# SUPPLEMENTAL RESPONSES TO CEC STAFF DATA REQUEST SET 1 (11,13,14, 19- 23, 31, 32, AND 34-36)

STACK SVY03A Campus (23-SPPE-01)

SUBMITTED TO: CALIFORNIA ENERGY COMMISSION

SUBMITTED BY: **STACK Infrastructure**

**Figure 1. Project Site and Nearby TAC and PM<sub>2.5</sub> Sources**

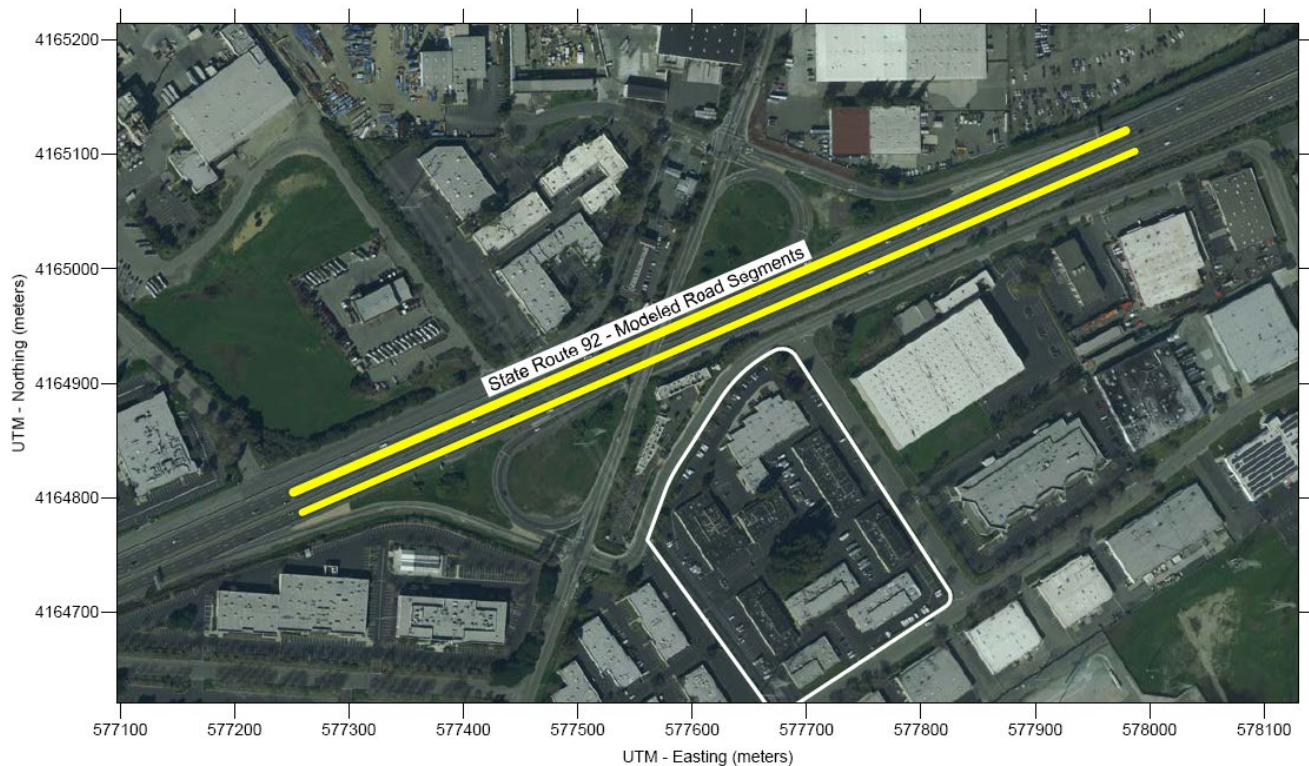
11. Please provide a schedule detailing when the cumulative air quality and public health risk assessment would be provided to CEC staff.

As discussed above, the project site is affected by several sources of TACs. Table 3 shows the cancer and non-cancer risks associated with each source affecting the project site. The sum of impacts from combined sources (i.e., all sources within 1,000 feet of the project) would be below

the BAAQMD air quality and health risk thresholds. Therefore, the impact from combined community risk would be considered less than significant.

**Figure 1**

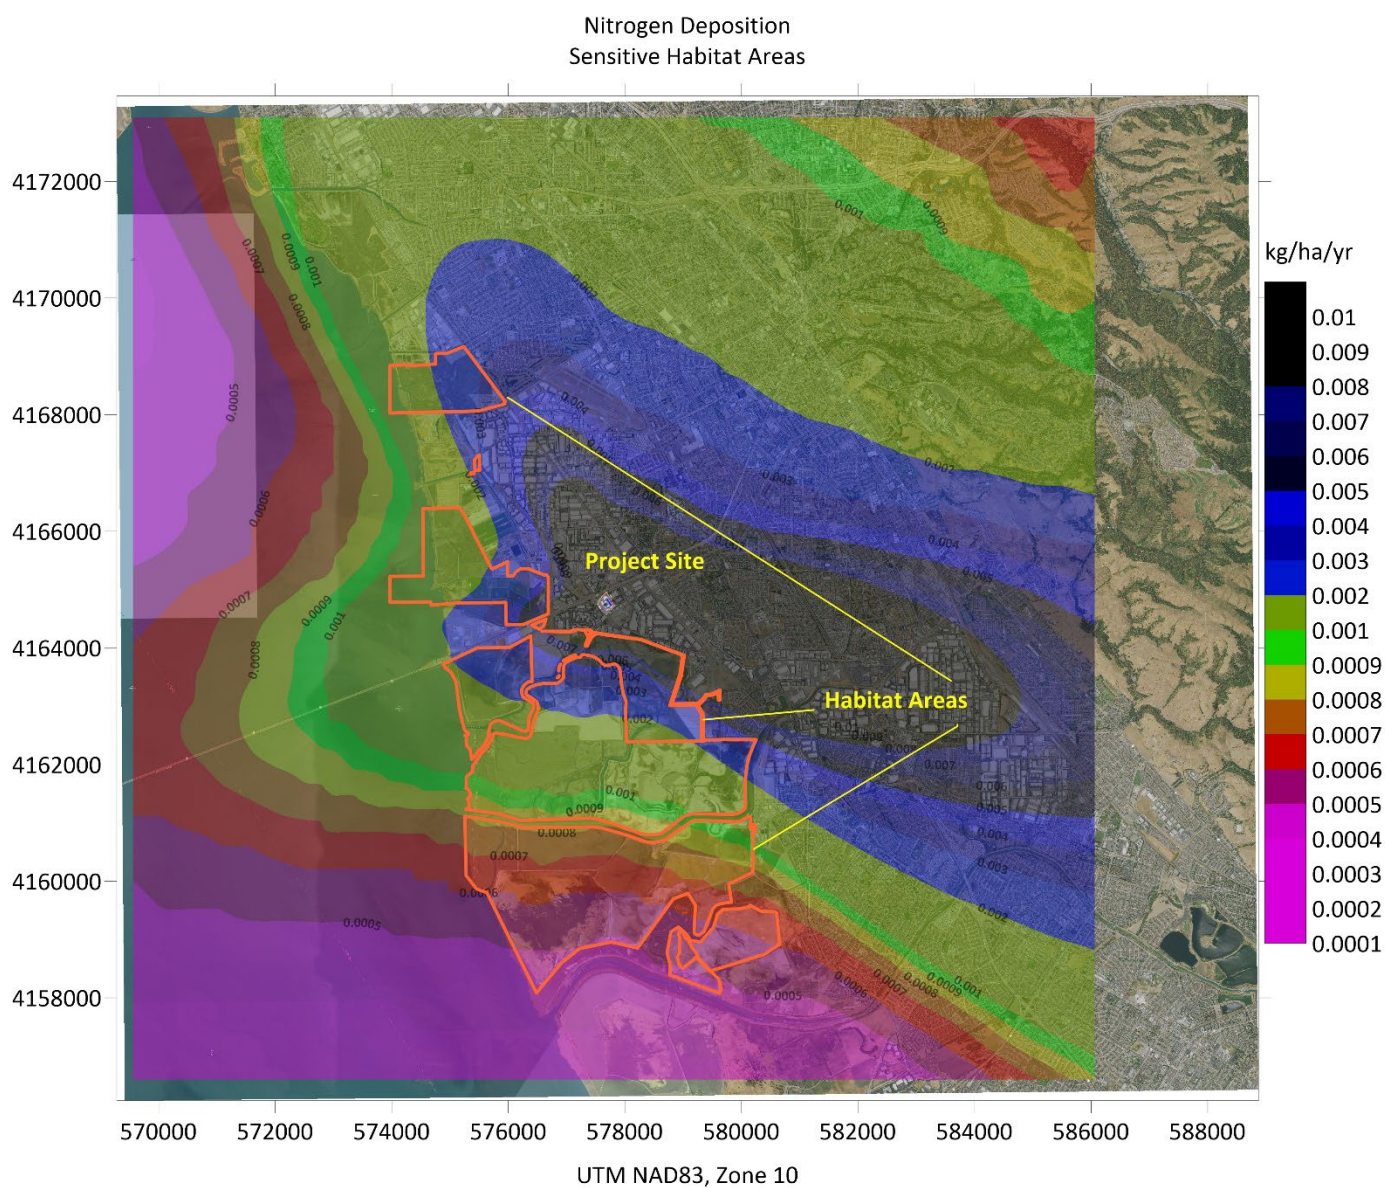
14. Submit a completed assessment of nitrogen deposition from the project on low-nitrogen habitats in the vicinity. The assessment must comply with the CEC's requirements for an SPPE Application contained in section (g)(13)(B)(ii) of 20 CCR Div. 2 Ch. 5 App. B, as follows:

*(ii) Provide an aerial map of the isopleth graphic depicting modeled nitrogen deposition rates. The geographical extent of the nitrogen deposition map(s) should include the entire plume and a radius of 6 (six) miles from the source, specifically identifying acres of sensitive habitat(s) within each isopleth (emphasis added). Modeling parameters and files shall be provided.*

The results of the analysis are presented in Figure 1.

Results of the wet and dry nitrogen deposition modeling are summed by AERMOD to produce annual deposition rates in units of grams per square meter (g/m<sup>2</sup>) for the entire 5-year meteorological period modeled, which are converted to kilograms per hectare per year (kg/ha/yr) for presentation in this report. As the critical habitats cover a variety of elevations and distances, the annual average deposition rates calculated for all receptors modeled in the critical habitat areas were used for comparison to threshold levels. The maximum project impact on nitrogen deposition rates would be 4.047 kg/ha/yr immediately adjacent to the facility. In the critical habitat area, the average deposition rates are on the order of 0.001 kg/ha-yr.

San Francisco Bay Area indicates that intensified annual grass invasions can occur in areas with nitrogen deposition levels of 11–20 kg/ha/yr, with limited invasions at levels of 4–5 kg/ha/yr (Weiss 2006a and Weiss 2007, as cited in CEC 2007). The maximum and average levels of nitrogen deposition from the project in the sensitive areas are far below levels necessary to cause adverse effects.

VERTICAL, DOUBLE CIRCUIT CONFIGURATION-GULL CROSSARMS

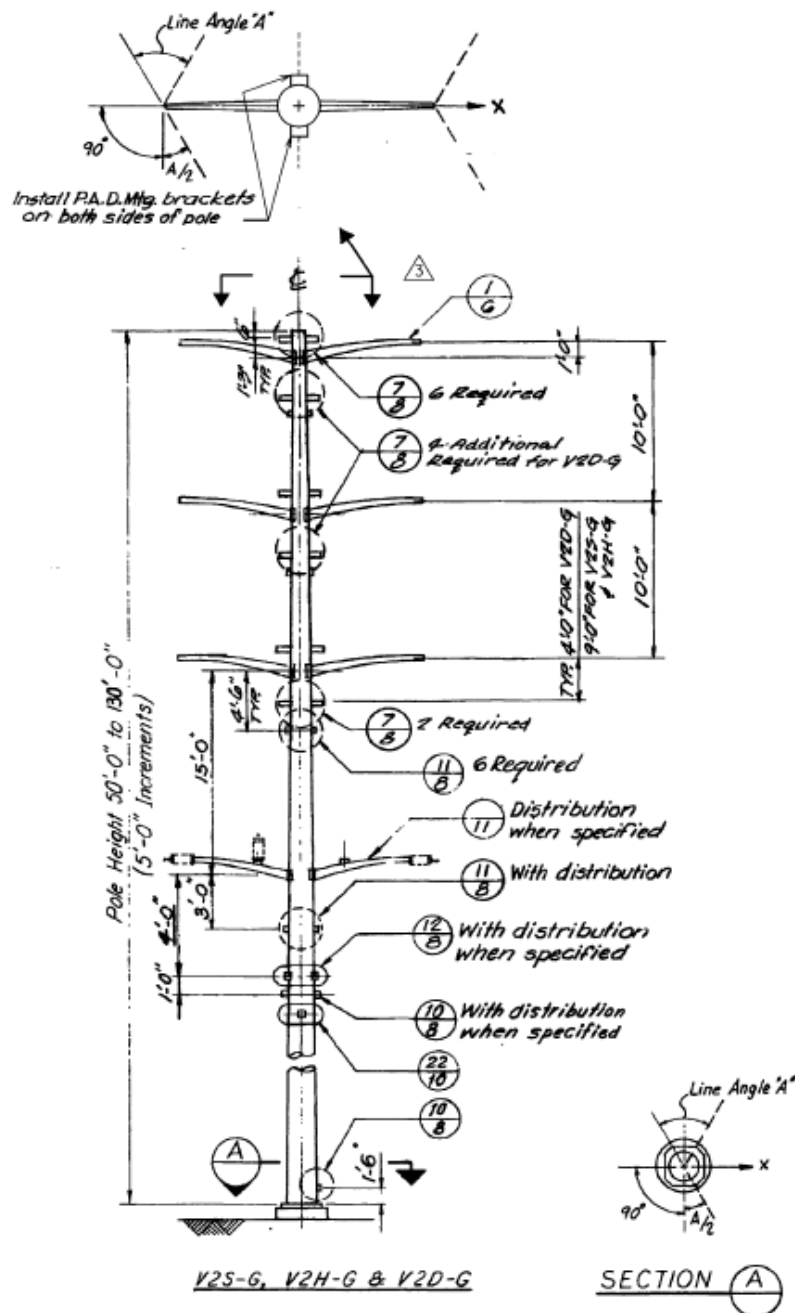
20. Please provide the conductor name, type, current carrying capacity, and the overhead conductor size for the 115 kV transmission lines which connect the existing PG&E Eastshore-Grant 115 kV line to the new switchyard. Provide a map showing the route and pole locations of the extensions.

Transmission line will use 2-795ACSS conductor. Substation will use 2-2300AAC. The route and pole locations will be determined during preliminary design. However, for purposes of conducting a CEQA analysis, the Staff can use the following figure to further augment the written description contained in the SPPE.

To serve the SVY03A Campus, PG&E will be constructing a “looped” transmission interconnection involving two offsite transmission line extensions. This would involve a line on the south side of the project that comprises a two circuits of 115 kV OH (Overhead) Transmission line (T-Line) from an existing PG&E Eastshore to Grant 115 kV Line which is located on the south side of the project.

Final design of the transmission line has not been completed. However, for purposes of the CEQA analysis Staff can assume the following typical pole configuration for between 8 and 12 poles.

**Figure 2. Sensitive Habitats in the Vicinity of the Project Area**

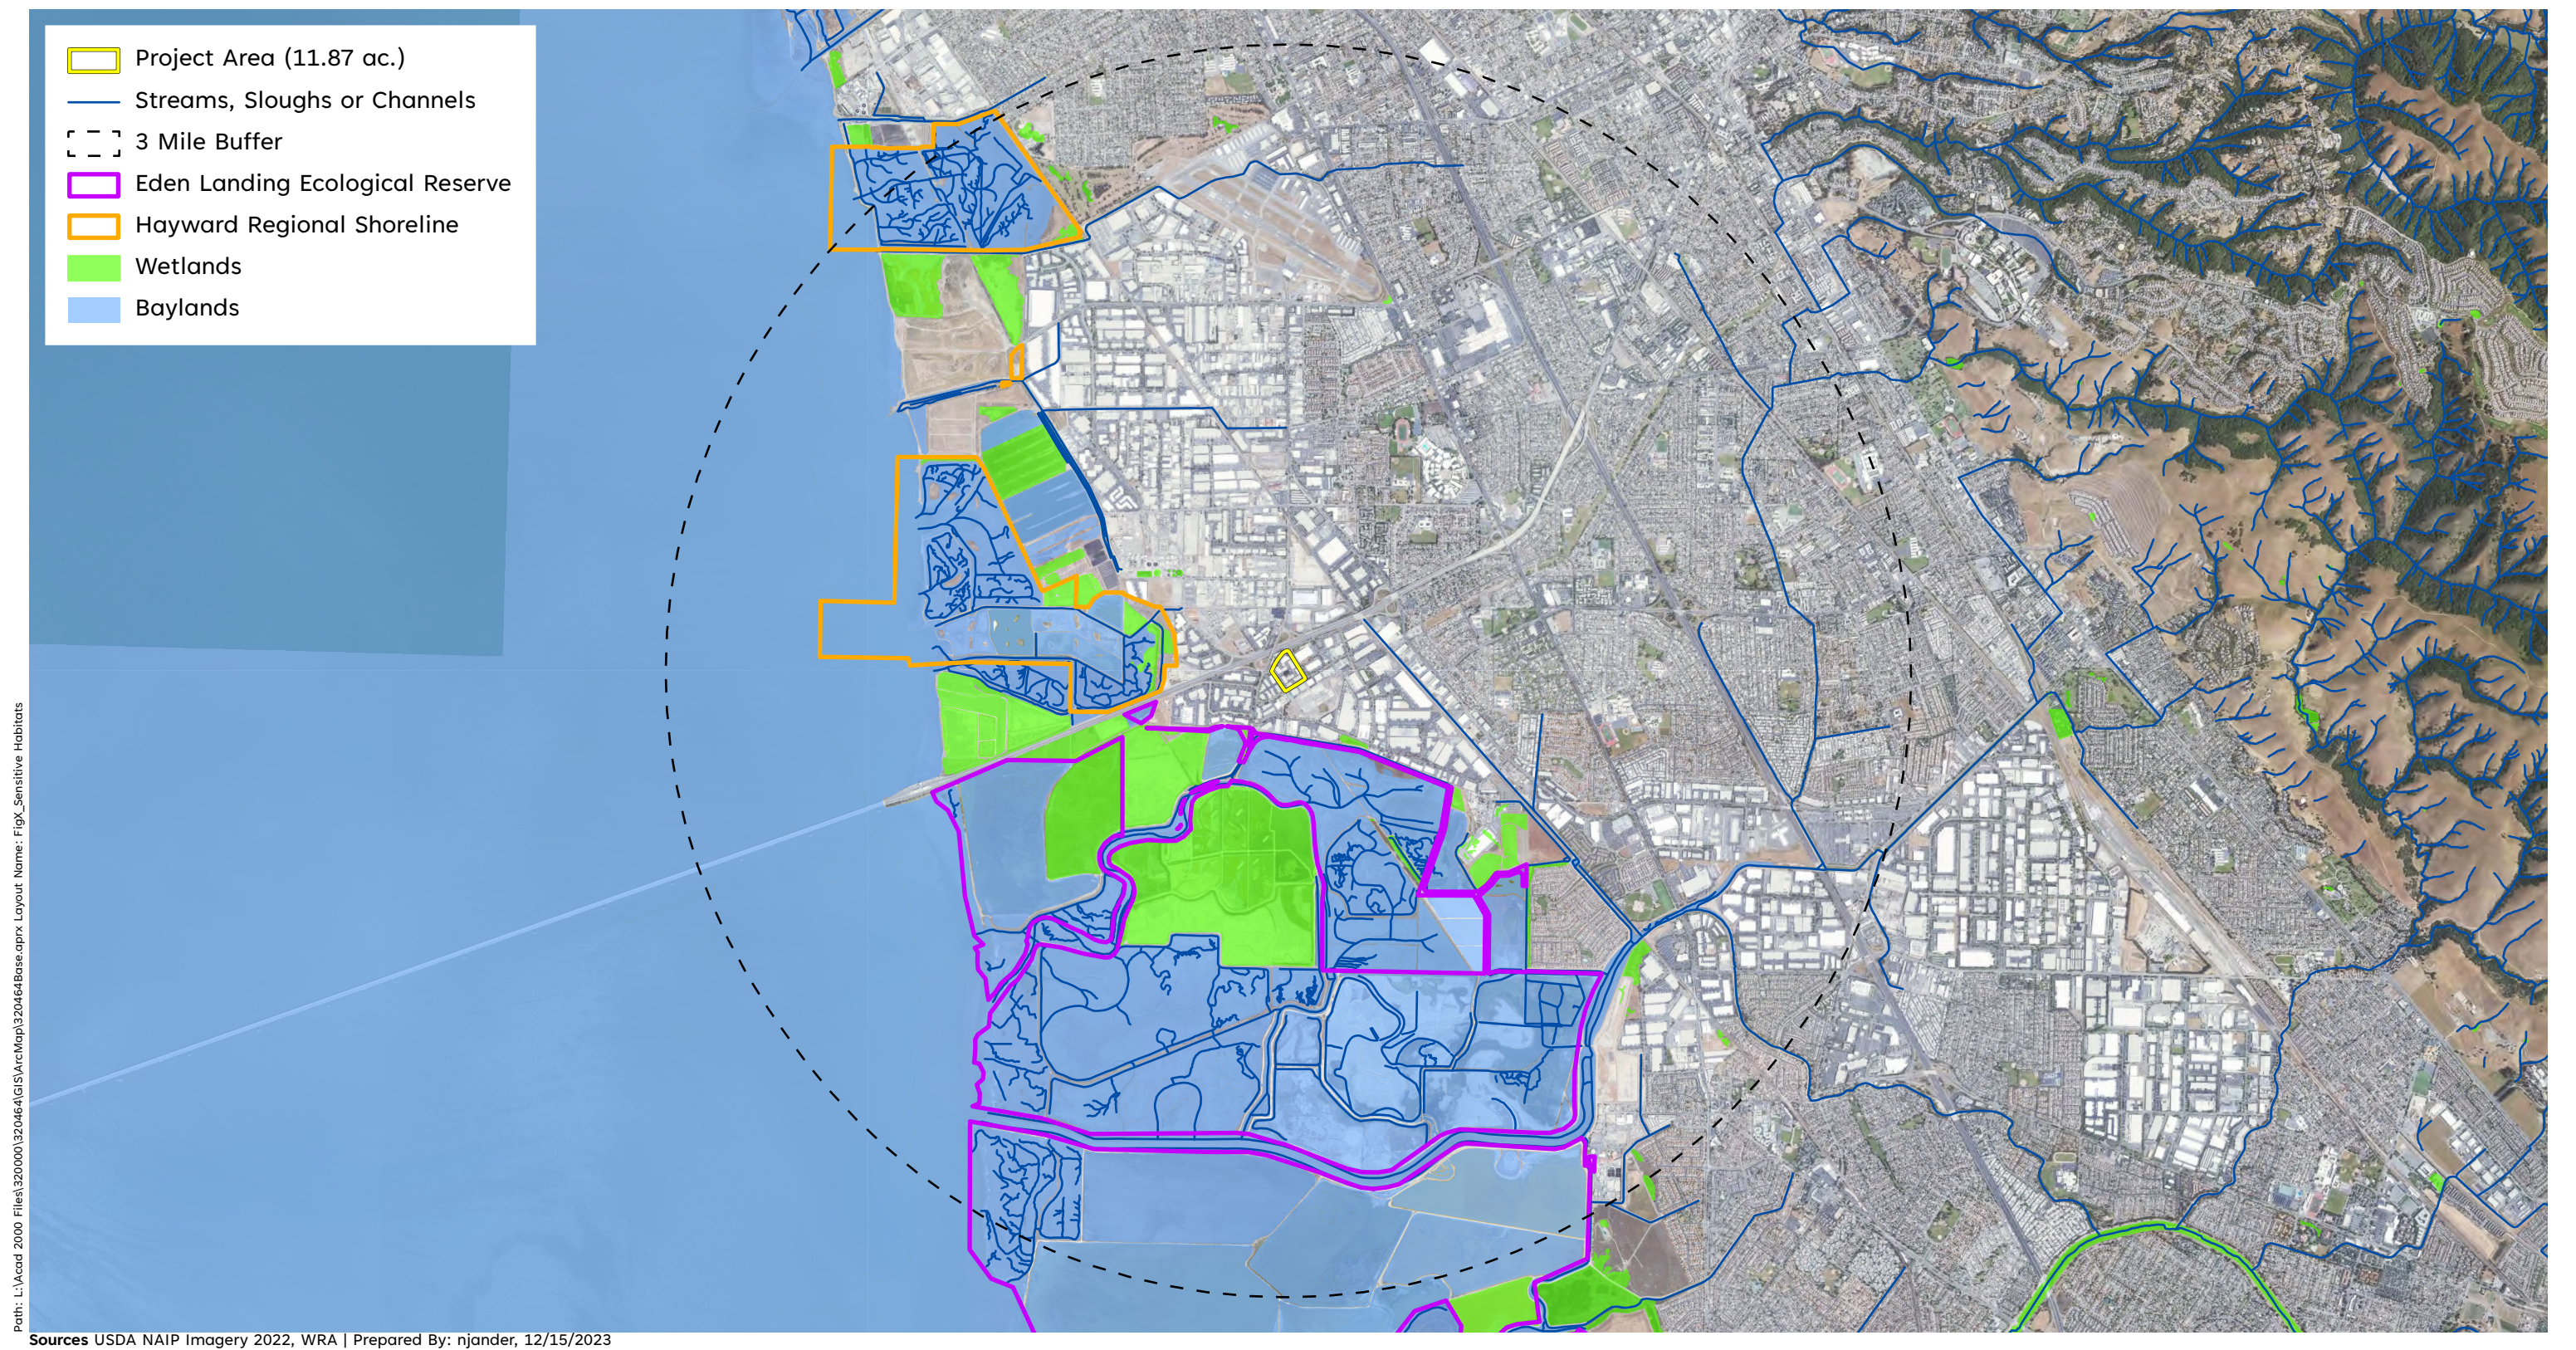
13. Provide detailed maps at a scale of 1:6,000 or color aerial photographs taken at a recommended scale of 1-inch equals 500 feet (1:6,000) with a 30 percent overlap (provided under confidential cover) and 1:350,000 (for public viewing) that show the proposed project site and related facilities, biological resources including, but not limited to, those found during project-related field surveys and in records from the CNDDB, and the associated areas where biological surveys were conducted. Label the biological resources and survey areas as well as the project facilities.

Enclosed Figure 1 details CNDDDB documented occurrences of special-status plants and wildlife species within the vicinity of the proposed project area and has been scaled to the requested one inch equals 500 feet (1:6,000). Two special-status plants and four special-status wildlife species have been documented to occur in the vicinity. Given the sensitivity of these species, the data provided in California Department of Fish and Wildlife's California Natural Diversity Database (CNDDDB) is confidential not for public distribution. As such, this figure has been labeled as Confidential and should not be distributed beyond the CEC's reviewing team. Figure 2 depicts known aquatic resources within the vicinity of the project site along with boundaries of known reserves and/or parks. A three-mile buffer has been included to visualize aquatic habitats within closer proximity to the project site. Eden Landing Ecological Reserve and the Hayward Regional Shoreline are both in the vicinity and situated west (north and south) of the project site and contain sensitive aquatic resources. Additional aquatic resources, such as streams, sloughs, or channels are also depicted.
